Maxtor Corporation
500 McCarthy Boulevard
Milpitas, CA 95035 USA

To: T10 CAP Working Group
Contact: Mark Evans
Phone: 408-894-5310
Email: mark_evans@maxtor.com
Date: 11 September 2003

Subject: SAM-3, new Terminate Data Transfer transport protocol service and related clarification

Figure 1 — SCSI transport protocol service model for Terminate Data Transfer

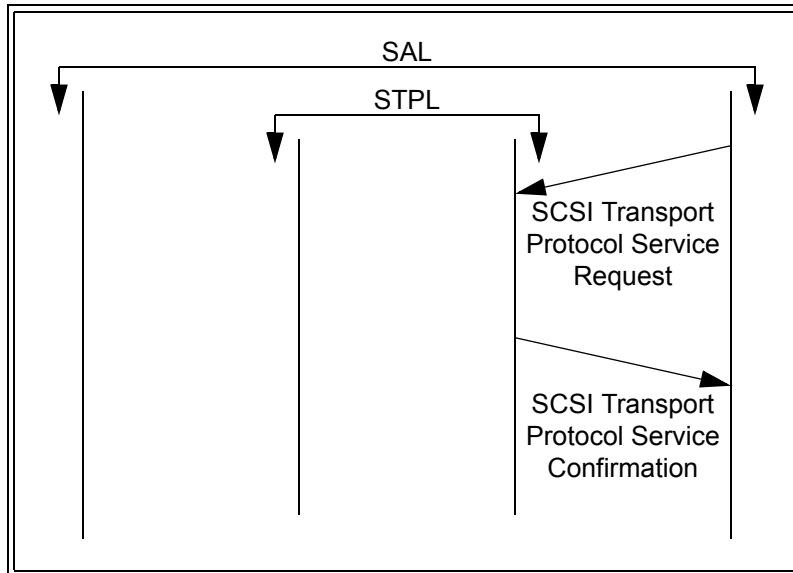
Item 1) Add the following into clause 4.15 The SCSI model for distributed communications:

When a device server invokes a Terminate Data Transfer SCSI transport protocol service, the interactions required to complete the service do not involve the SCSI Transport Protocol Service Interface or the application client. Only the STPL in the SCSI device that also contains the device server is involved. Figure 3 shows the relationships between the SCSI transport protocol service types involved in a Terminate Data Transfer request.

Figure 2 — Device server Terminate Data Transfer transaction and related STPL services

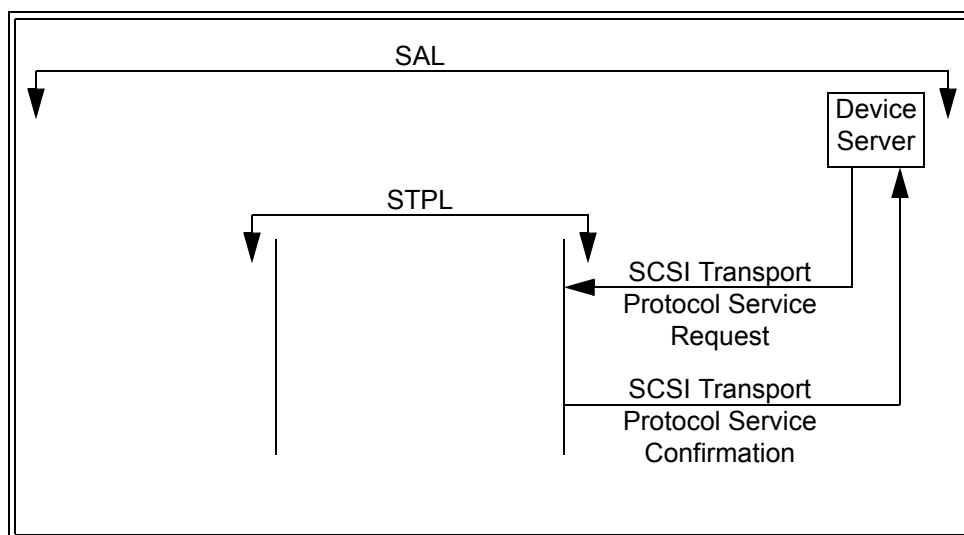
Figure 4 shows how SCSI transport protocol services may be used to process a device server Terminate Data Transfer transaction.
